**PEER REVIEW ASSESSMENT OF A
LEVEL 1/2 HYDROGEOLOGICAL TECHNICAL REPORT
SUBMITTED IN SUPPORT OF A QUARRY ZONING
APPLICATION REVIEW**

Proposed Norval Quarry (Brampton Brick Limited)
West Half of Lot 12, Concession 6
City of Brampton (former Township of Chingacousy)

May 2011

PROJECT NO.: 111-53308-00

FIGURE 3: Proposed Quarry Operational Plan – Final (Long Environmental, 2010)

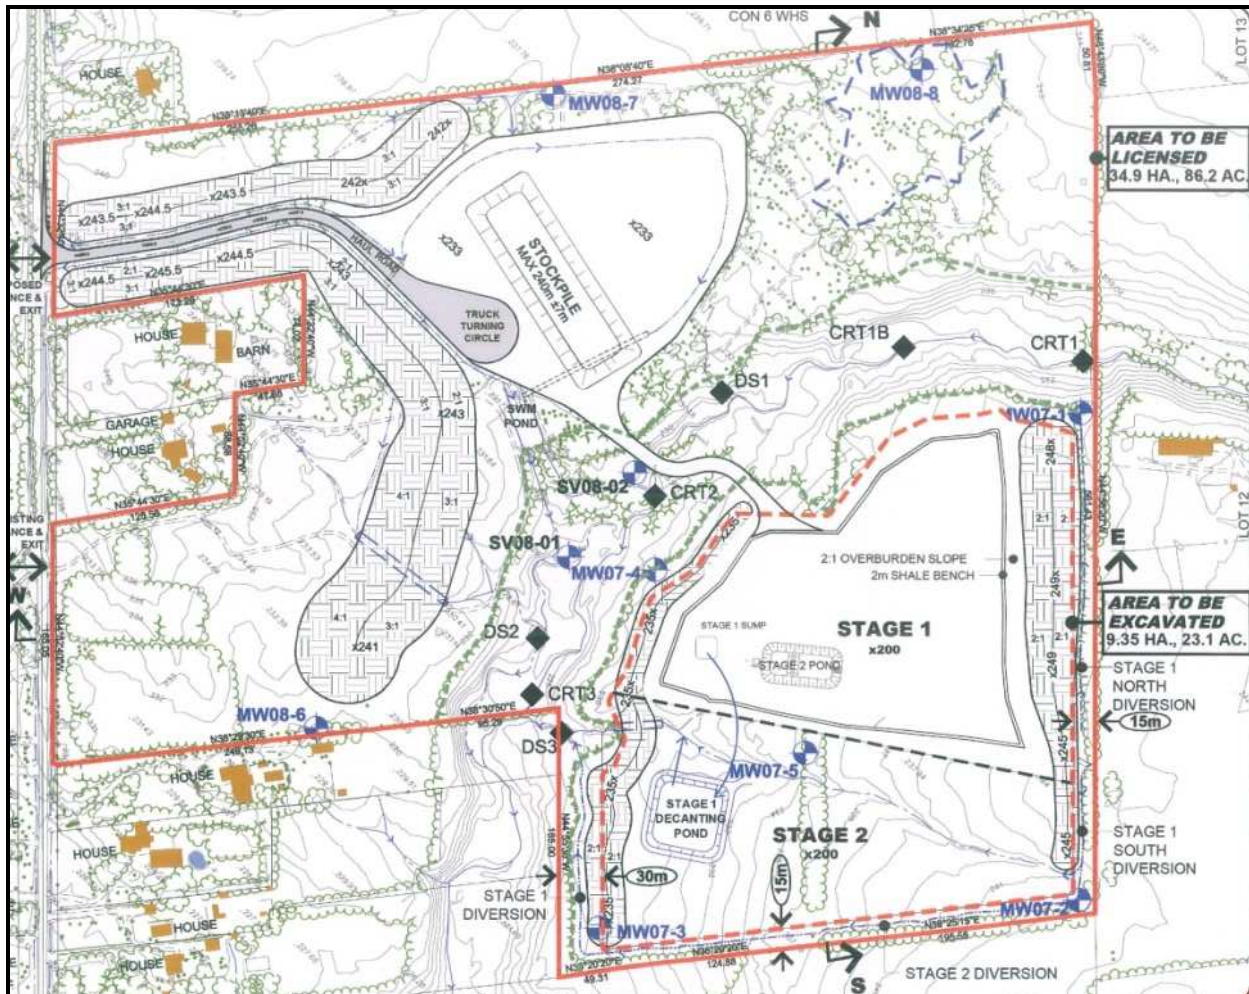
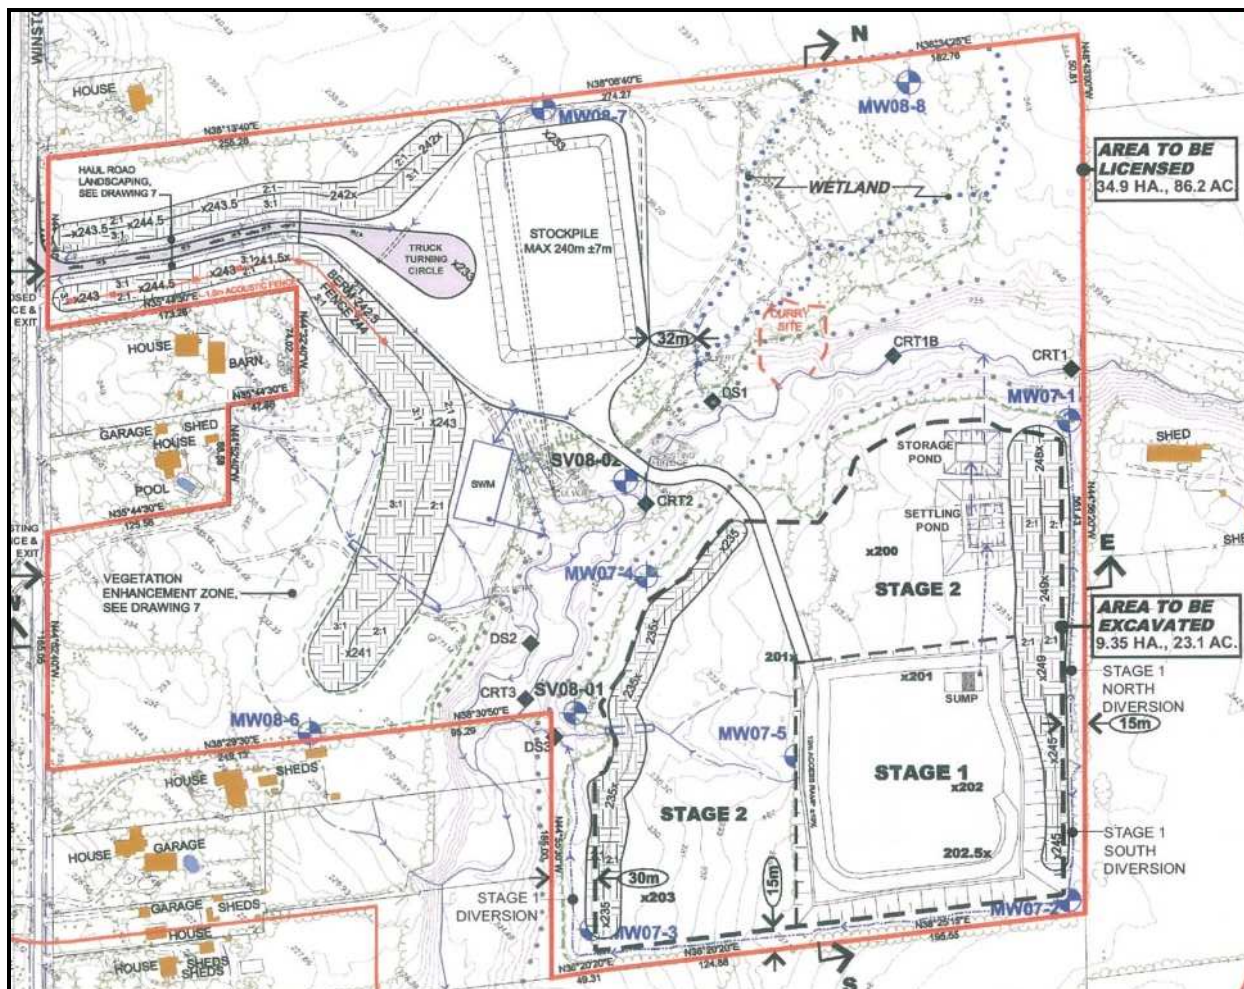
1.3	<ul style="list-style-type: none"> → The generalized phasing plans for the proposed quarry operation are shown on Figure 1.2 and are reported to be based on the “April 2010 Draft Site Plan”. In this regard, it is also reported that a “Final Site Plan” was produced in July 2010, and that “minor modifications” occurred between the “Draft” and “Final” Site Plan. If the July 2010 Final Site Plan was available at the time of report preparation, it is questioned why the report figures were not updated to incorporate those “minor modifications”? In contrast to the figures however, the report text has been updated to reflect the current proposed operational plan.
Figure 1.2	<ul style="list-style-type: none"> → Indicates incorrect locations for operational water management aspects of proposed quarry operation. As a matter of correctness, this figure should be updated to reflect the current proposed operational plan.
